## **Planning Sub-Committee B**

## **Supplemental Agenda No.1**

<b>Item No:</b> 7.1, 7.2 & 7.3	<b>Classification:</b> Open	<b>Date:</b> 22 November 2021	<b>Meeting Name:</b> Planning Sub Committee B
<b>Report title:</b>		<b>Addendum report</b> Late observations and further information	
<b>Ward(s) or groups affected:</b>		Borough and Bankside and North Bermondsey	
<b>From:</b>		Director of Planning and Growth

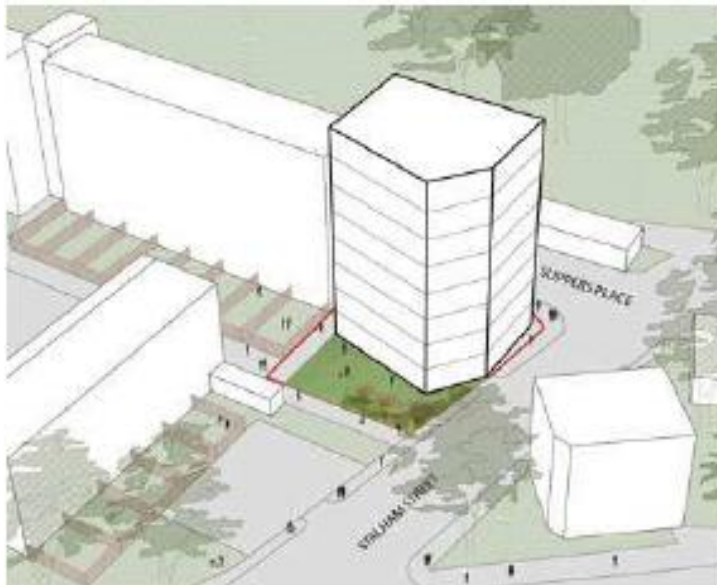
21. The objector refers to a report which is the advice given to the applicant pre-application stage where different massing and design of building was proposed. The image below shows the building that was proposed at that stage, it was amended in line with the advice provided.
